**CITY OF ALLENTOWN**

**R167 – 2023**

**Certificate of Appropriateness for work in the Historic Districts:**

**Historical Architectural Review Board  
COA Final Review Sheet**

**Porch column to be replaced, 2023.  
(Applicant)**

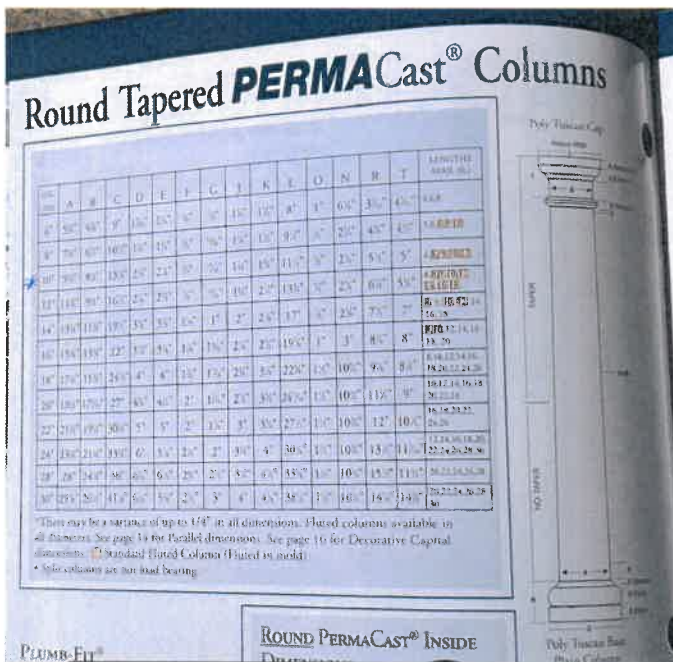
Building Standards has inspected the property and determined that two porch columns are rotted and require replacement. The owner has provided staff with specs on matching columns in fiberglass (PermaCast) and wood. The owner noted that the wood columns are hollow, though loadbearing, and that he prefers the fiberglass columns. The proposed columns have a tapered shaft and matching components. While a material change, they would replicate the appearance of the historic. Staff finds that the columns do not comply with Guideline 3.7.4 because of the material change, but do comply with Guideline 3.7.8. Despite the material change, staff finds the proposed alternative to be compatible and acceptable.

Mr. Lichtenwalner moved to approve with conditions the application presented on 10/2/2023 to replace wood porch columns with fiberglass columns and to reinstall window sashes at an infilled second-story opening, pursuant to Chapter 3, Section 3.5 Windows and Section 3.7 Porches & Steps, provided that the reinstalled window sashes have either spandrel glass or a painted panel behind the window. Mr. Huber seconded the motion, which carried with unanimous support.
